DEWBERRY RESPONSE TO USGS FISH SPRINGS TOPOBATHYMETRIC LIDAR

Produced for U.S. Geological Survey

SEPTEMBER 7, 2023

Figure 2. Images 1 and 2 from Stakeholder, showing channel in question via orthoimagery (left image) and the delivered topobathymetric DEM (right image).

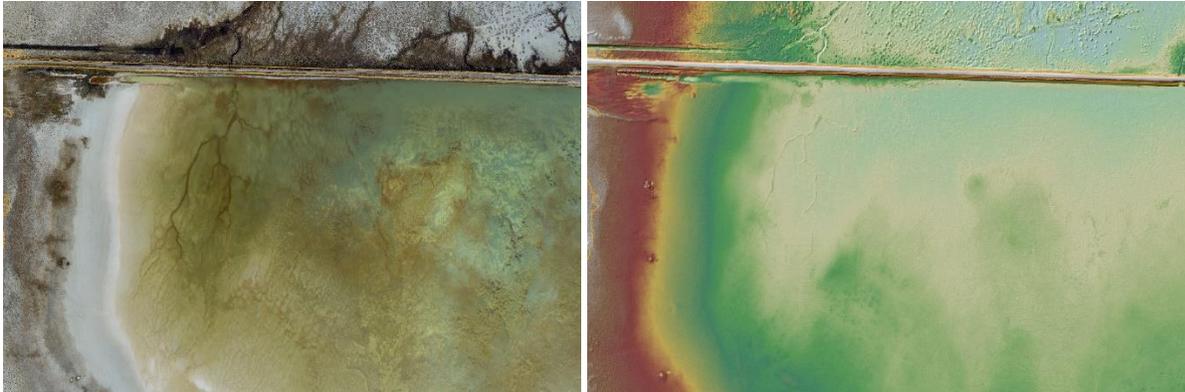
“Image 1 provides a clear look at a submerged channel (using the 10cm ortho imagery). The second image shows this channel as a higher elevation in the DEM.”

The feature in Figure 2 is located in tile 12STK980190. The US Fish and Wildlife Service (USFWS) identified a channel that appeared higher in elevation in the digital elevation model (DEM). The point cloud shows a consistent, well-modeled feature, which is why Dewberry had originally classified it as bathy bottom (class 40). Dewberry investigated this channel further and verified that this feature has always been raised/elevated in all versions of data; the higher elevations were not introduced from refraction correction, or any other processing performed by Dewberry. From imagery, it appears as though the channel could be vegetated, but the point cloud does not represent variations in lidar returns typically associated with vegetation, even low vegetation. There is a potential that algae or some other smooth aquatic vegetation was present in the channel at the time of collect.

Dewberry requested a field check be conducted at this area to better quantify the area in question. Dewberry classified the channel to reflect field verification and/or client preferences which had the feature in question reclassified to water column, and to interpolate across the feature rather than void out in the DEM. Figures 3 and 4 compare the channel as delivered, modeled in bathy bottom, to a topobathymetric DEM and lidar point cloud profile of the channel when the elevated feature is reclassified to water column.

FWS did go out and get eyes on the area in question- the Gadwall drainage area, however “wind/wave action and turbid water made it difficult to get pictures of the exact area in question. It was determined that the bulk of the feature is vegetated, mostly with spiral ditchgrass, a submerged aquatic plant that is seen throughout the refuge. Tellingly, it grows in dense patches in drainages and ditches. That would align with FWS’s contention of what this feature is on the ground. Figure 5 shows the vegetation in question, but without a drone mounted camera- which is not allowed within the restricted airspace, this is all that could be provided at this time. The vegetation in question is both dense beneath the surface, and floating to the surface in patches.”

Figure 6. Images 3 and 4 from Stakeholder.

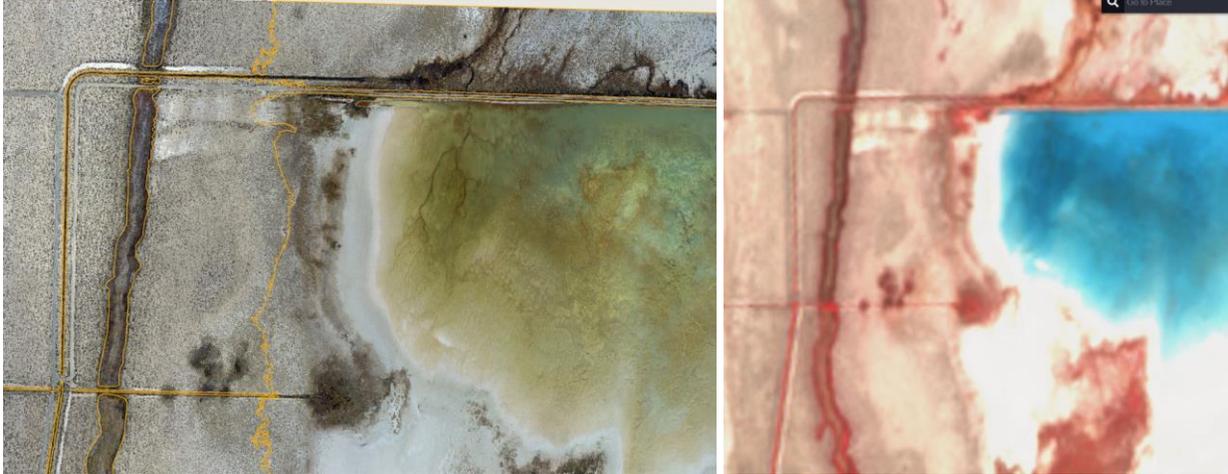
Question 2: “The remaining images demonstrate our confusion at how the Refraction polygons were created (and used) as they do not seem encapsulate what can be easily photo-interpreted in the 10 cm imagery as open water. Are we missing something here in terms of the green laser technology? We also included a CIR image from the same date captured from Sentinel 2 imagery which helps delineate standing water. Adding to the confusion is these polygons seem to directly influence the las point classification. Some open water pools are excluded while many dry channels (with vegetation) and clear upland areas are included. We would have expected the large dry basins on the north end of the refuge to be classed as ground.” See Figures 5-6.

Dewberry's refraction extent polygons are intended to show the extent of where refraction correction was applied and are used to delineate ground- class 2 vs. bathy bottom- class 40 classification in the final point cloud.

Upon further review it was determined that an incorrect, earlier version of the refraction extents was used for the final classification and delivered to USGS (Figure 9). Dewberry generates a couple different versions of refraction extents throughout our production process. The first version, incorrectly delivered, is a much more expansive version of "potential" areas requiring refraction correction. This version is used to help us determine where water may be present. This version is then reviewed and revised, using a combination of DEMs, ortho imagery, intensity, Max Height Separation Raster (MHSR), difference rasters, and additional ancillary datasets, to reflect the actual extent of bathy bottom deep enough to require refraction correction. Priority is given to substantial areas that were clearly wet or could be perceived as wet. Some nominal areas of potentially wet ground were not collected when perceived dense vegetation was also present (Figure 10). These vegetated areas often appear as darker features in the intensity but do not correlate well to the ortho imagery and/or MHSR. In addition, Dewberry did not include areas that could be perceived as dry or mostly dry floodplains as they did not meet the depth criteria for refraction corrections, nor could they be clearly perceived as wet (Figure 11).

Figure 8. Images 6 and 7 from Stakeholder, showing bathy bottom (class 40) classified points within refraction extents (left image) and ground (class 2) classified points outside of refraction extents (right image).

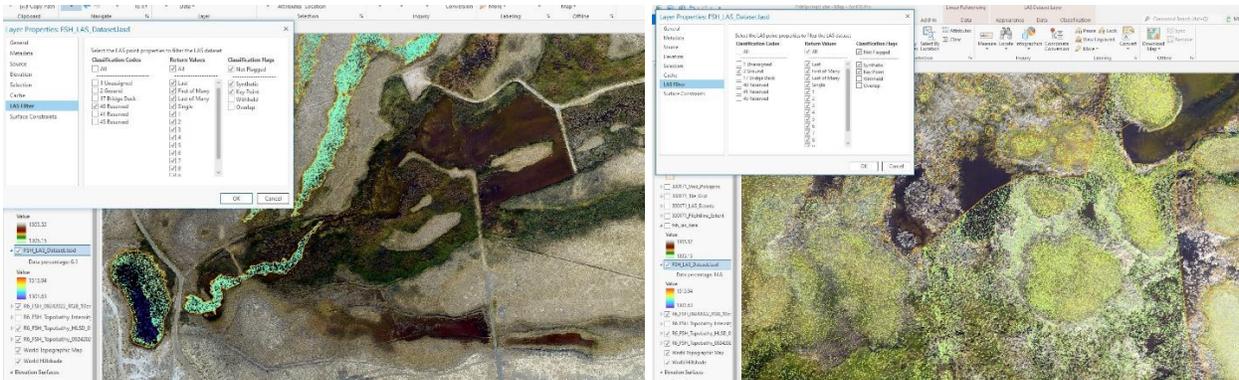
Question 3: “The last example also shows another instance where the refraction extent is drawn considerably different and its effects on the las point classification. This does not make sense to us. While the overall DEM surfaces look good and the surveys indicate the accuracy is acceptable, we have these concerns which we can’t square up.” See Figures 7-8.

Lastly, Dewberry applies ground (class 2) and bathy bottom (class 40) classifications based on the refraction extents so that all grounded points within the refraction extents are classed to class 40 and all grounded points outside of the refraction extents are classed to class 2.

Dewberry has verified that the refraction correction was correctly applied to the Fish Springs lidar point cloud, but that the incorrect version of refraction extents was used for the final classification steps. Dewberry has updated the lidar point cloud classification to match the correct, final version of refraction extents (Figure 12 and Figure 13). The updated lidar point cloud and correct version of refraction extents will be redelivered. The redelivered refraction extents and updated point cloud resolves questions 2 and 3. This correction does not impact the delivered topobathymetric DEMs.
